DOCKETED	
Docket Number:	25-OPT-02
Project Title:	Prairie Song Reliability Project
TN #:	266610
Document Title:	Data Request Response 2_Part 1
Description:	N/A
Filer:	Erin Phillips
Organization:	Dudek
Submitter Role:	Applicant Consultant
Submission Date:	10/15/2025 11:25:37 AM
Docketed Date:	10/15/2025

Data Request Response No. 2

Prairie Song Reliability Project

CALIFORNIA ENERGY COMMISSION

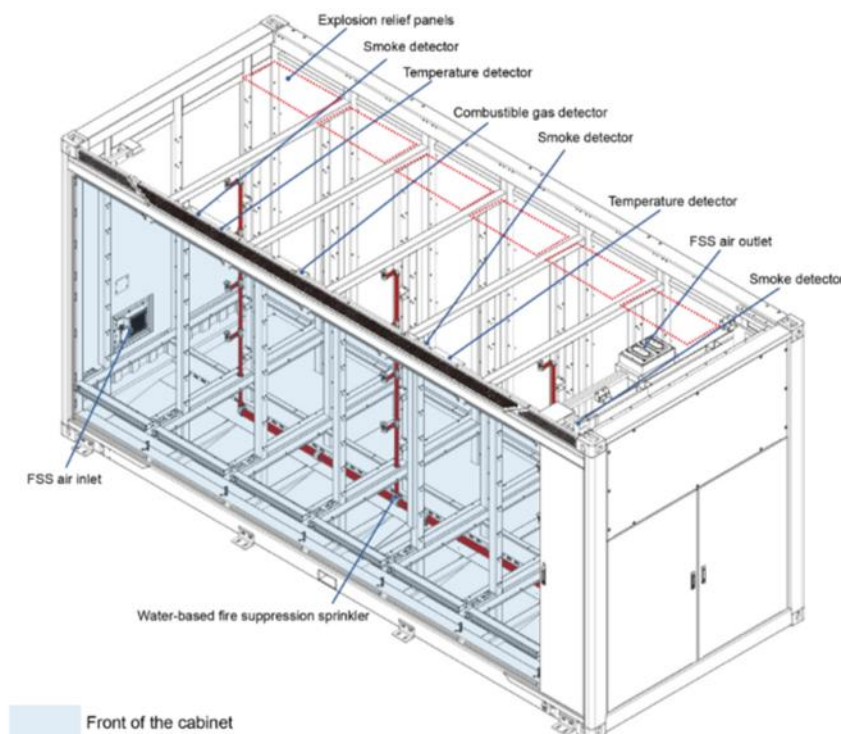
DR HAZ-3. Provide a schematic and complete description of the proposed explosion-control systems (e.g., exhaust systems, deflagration-relief venting systems, barricades, etc.) for the representative BESS enclosure. Provide a description of how the proposed explosion control systems will comply with the applicable NFPA standards (e.g. NFPA 68, 69, 855, etc.) and the Los Angeles County Fire Department requirements.

DR HAZ-3 Response. The Power Titan II is equipped with an automatic fire alarm and linkage control system, vent panels, a combustible gas detection and alarm system, and an exhaust system. It is equipped with combustible gas detectors, smoke detectors, and temperature detectors. If any abnormality is detected, the battery system controller (BSC) connects to local controller (LC) via Ethernet for alarm signaling, control of the battery enclosure shutdown, and control of the system for corresponding logic control.

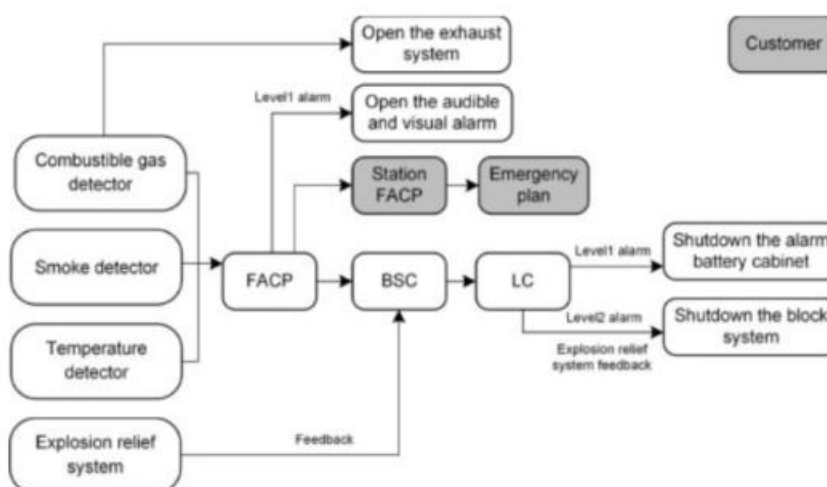
DR HAZ-4. Provide a schematic and complete description of the proposed gas detection systems for the representative BESS enclosure. Provide a discussion of the toxic vapors/emissions that could be produced if a battery container is damaged or thermal runaway occurs. Provide a discussion of the specific gas(es) or vapor(s) intended to be detected.

DR HAZ-4 Response. The BESS enclosure will be equipped with a flammable gas detector, an air inlet device, and an outlet device. When the gas concentration reaches 10% lower explosive limit, the flammable gas detector triggers to open the emergency ventilation system/ECS.

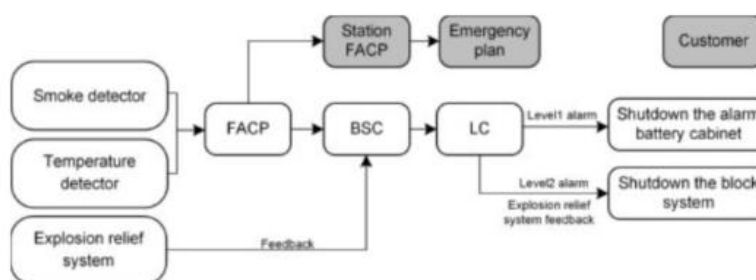
DR WS-15. Provide a schematic and complete description of the proposed fire suppression systems for all project buildings, including the two O&M buildings, pump enclosure, control building, etc.

DR WS-15 Response. Per California Fire Code 903.2 – “An approved automatic fire sprinkler system is required in all new buildings and structures, notwithstanding the use and occupancy thereof, when the total aggregate floor area exceeds 5,000 square feet.” All Project structures will have a total aggregate floor area less than 5,000 square feet and will not contain sprinkler systems.

FIGURE 4-2
Alternative Sites
Prairie Song Reliability Project

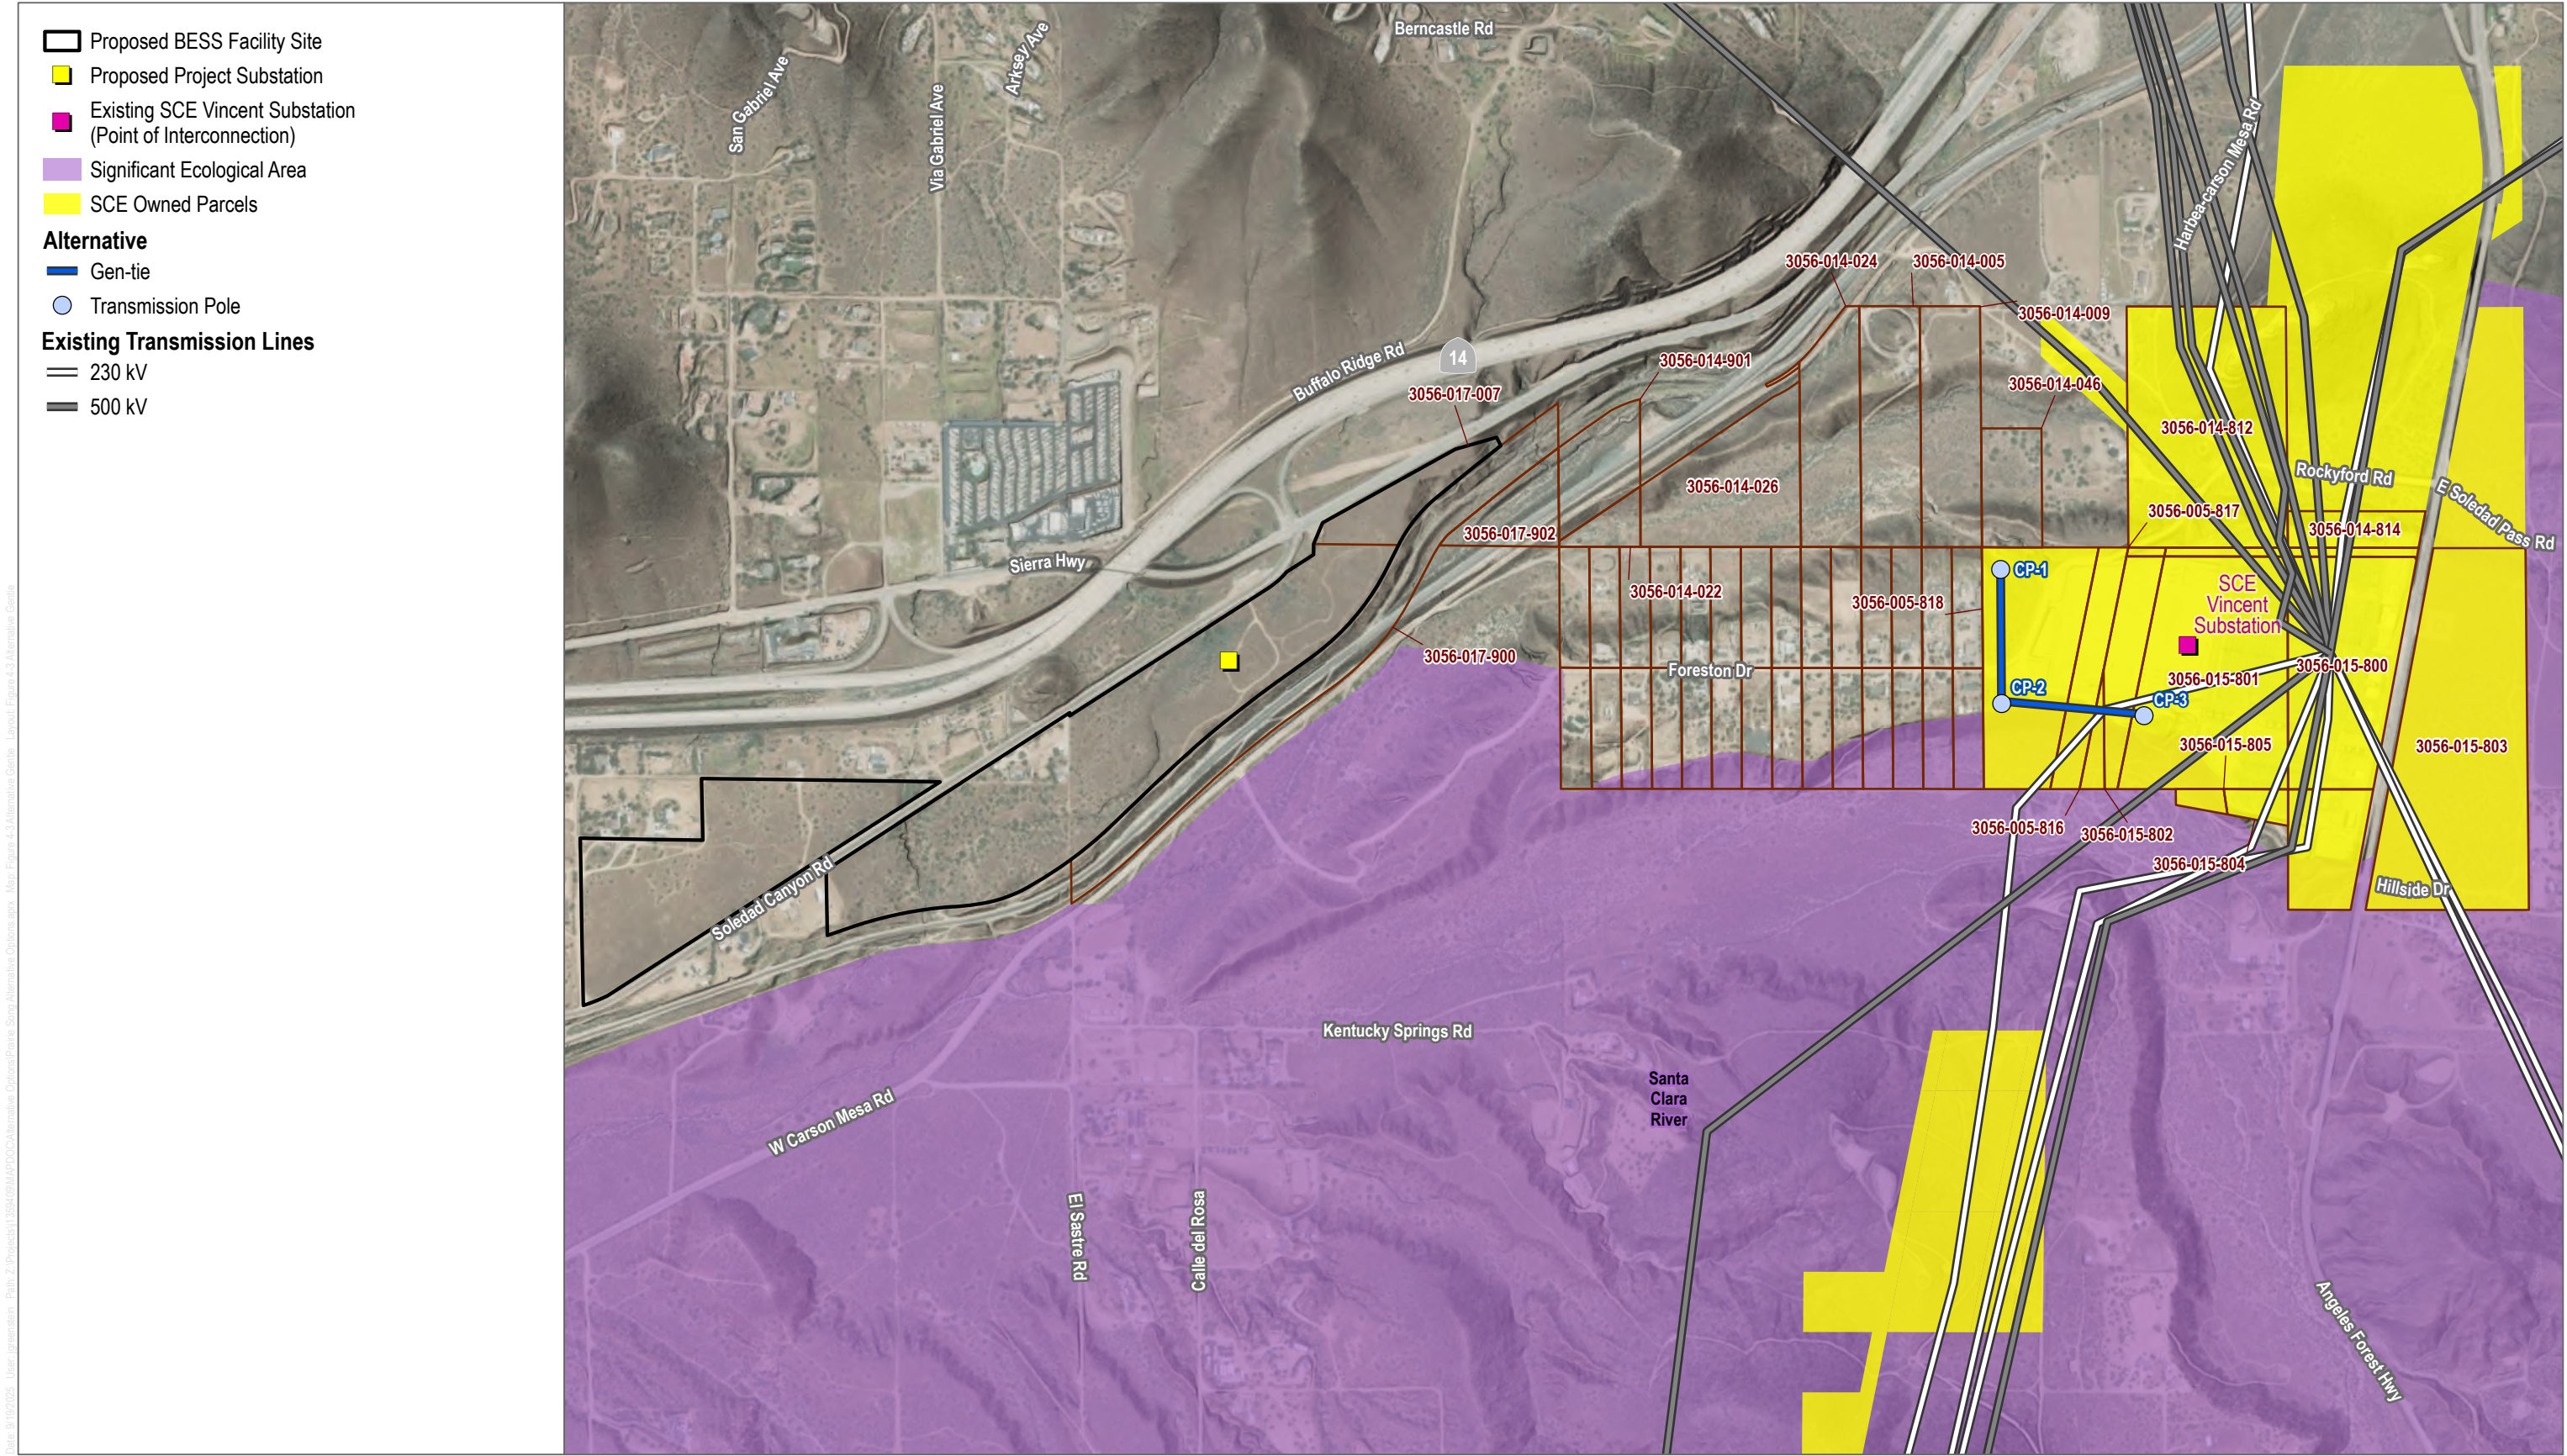
- a. Provide a map (preferably with a KMZ file provided) and description (i.e., location, parcel number, size, etc.) of all alternative site locations initially considered for the project, including sites that are located outside of the two-mile radius of the Vincent Substation and smaller sites that could accommodate a 45-acre reduced project alternative; and

DR ALT-1(a) Response. In response to Data Request ALT-1(a), an expanded alternative site location analysis was completed. The expanded alternative site analysis is two-pronged as it looks at (1) alternative locations that are within a larger radius of the Vincent Substation (6 miles as opposed to 2 miles) and (2) alternative locations that could support a smaller 45-acre reduced project alternative. Please refer to the redline version of Section 4, Alternatives, specifically Section 4.5.2 and Sections 4.9 through 4.13 for the expanded alternatives analysis. A KMZ file was provided to CEC staff via Kiteworks on October 9, 2025.

FIGURE 3.2-2
Protected Areas
Prairie Song Reliability Project

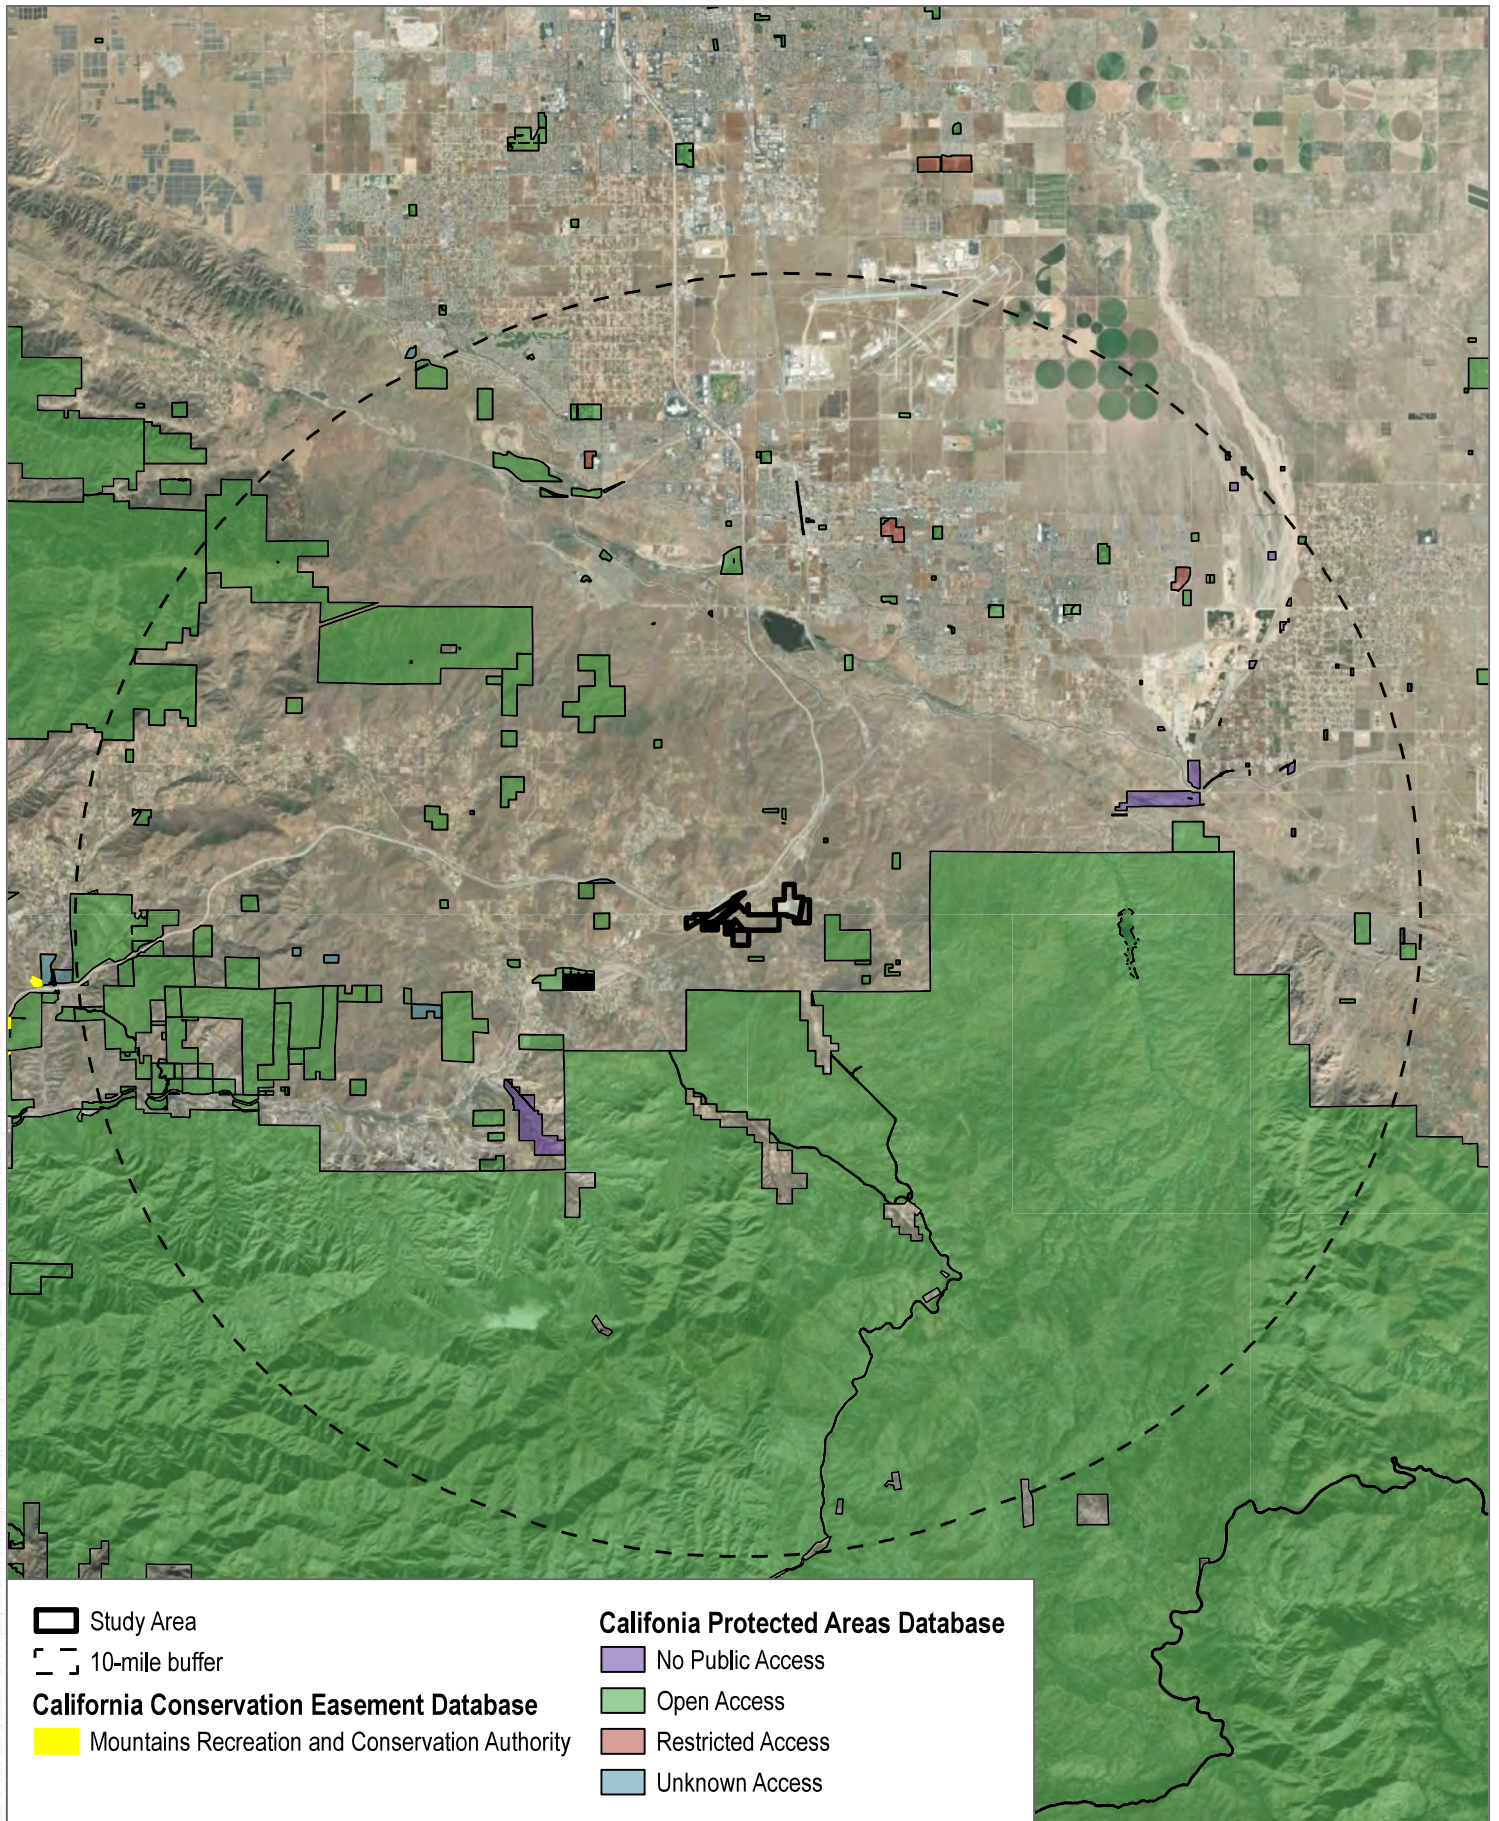
Figure 3.2-2 in the Application (TN 264413) depicts Mountains Recreation and Conservation Authority (MRCA) lands outside a 10-mile buffer distance from the project site. However, page 3.2-4 of states that the northern gen-tie option would span parcels managed by the MRCA that are deed restricted for open space use.

DR BIO-15. Please provide an updated map and/or written description that clarifies the location of MRCA lands in relation to the project components and resolves the apparent inconsistency between Figure 3.2-2 and the text on page 3.2-4.

DR BIO-15 Response. Please see the attached redline version of Section 3.2, Biological Resources. Additional language has been added throughout Section 2.2.2, CEQA Appendix G Assessment Criteria, to clarify the nature of the temporary and permanent impacts to sensitive resources. Please see updated Figures 3.2-2, Protected Areas, and 3.2-3, Local Protected Areas, for a representation of the protected areas surrounding the Project.
